HOLDOVER
Revised

BURLINGTON PLACE SUBDIVISION ADDITIONS

Revised for the May 4th meeting:

DETAIL SITE PLAN

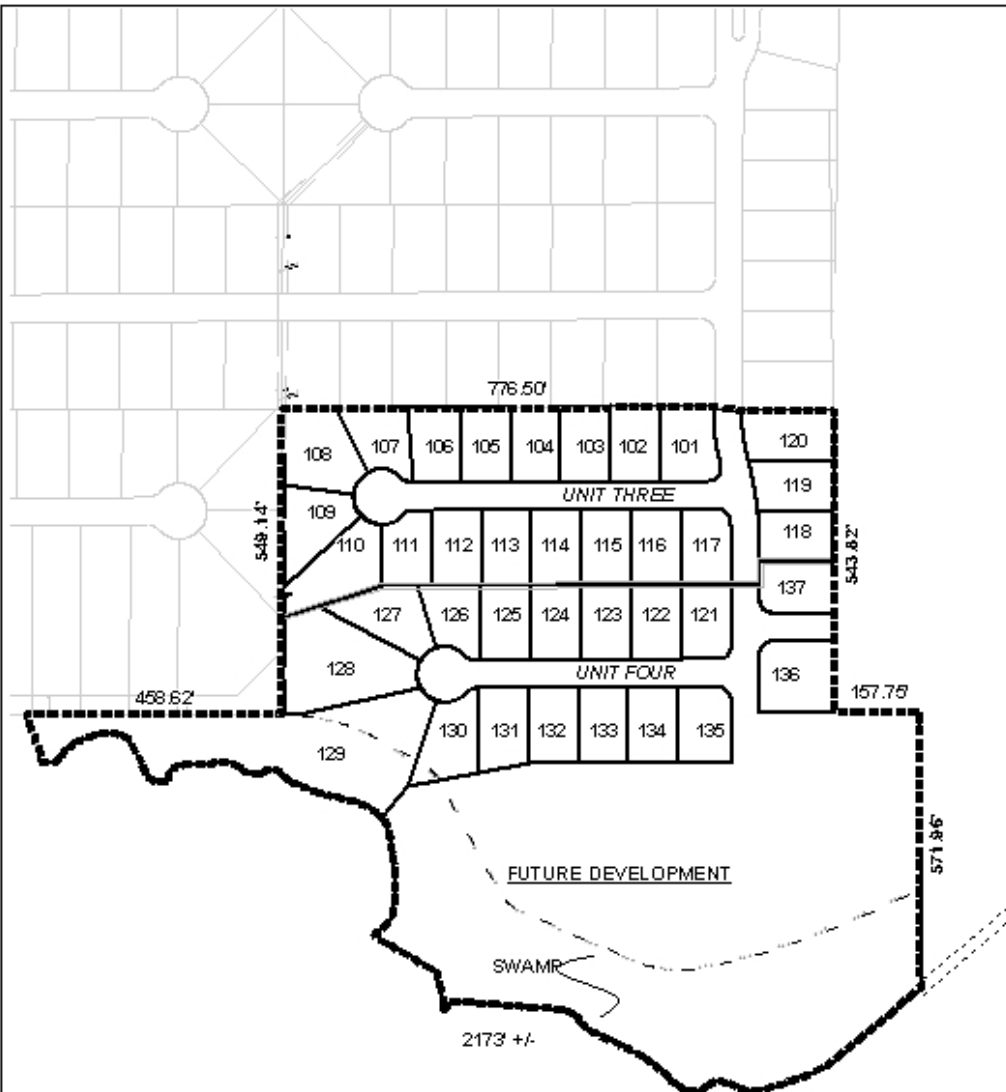
Units Three and Four, as proposed, generally appear to meet the minimum lot and layout requirements of the Subdivision Regulations, with the exception of proposed Lot 129. This lot occurs at the end of a cul-de-sac, and the wedge shape normally associated with such a lot is distended by approximately 460 feet to include a potential wetlands area, exceeding the depth to width ratio of Section V.D.3. As much of the potential wetlands area may be unsuitable for building, may be required for a drainage easement, and may not otherwise be subdivided in a suitable manner, a waiver of Section V.D.3. could be considered appropriate.

The 25-foot minimum building setback line, required in Section V.D.9., is not shown for the subdivision, but would be required on the Final Plat, if approved.

The plat is recommended for Holdover until the May 4th meeting for the following reason: 1) to allow the applicant to revise the preliminary plat to include the entirety of parcel R023402030000079., and provide additional labels and postage if necessary due to the inclusion of the entire parcel.

The purpose of this application is to subdivide two parcels into 37 lots and an area reserved for "future development." The application has been modified so that the third parcel in question is no longer included in the subdivision application, however, a street-stub is still provided to the East in order to allow for potential future development.

With a waiver of Section V.D.3. of the Subdivision Regulations to accommodate proposed Lot 129, the plat is recommended for Tentative Approval, subject to the following conditions: 1) depiction of the 25-foot minimum building setback line; 2) the approval of all applicable federal, state and local agencies, if necessary for wetlands, prior to the issuance of any permits or land disturbance activities; and 3) placement of a note on the Final Plat stating that any lots which are developed commercially and adjoin residentially developed property must provide a buffer, in compliance with Section V.A.7. of the Subdivision Regulations.
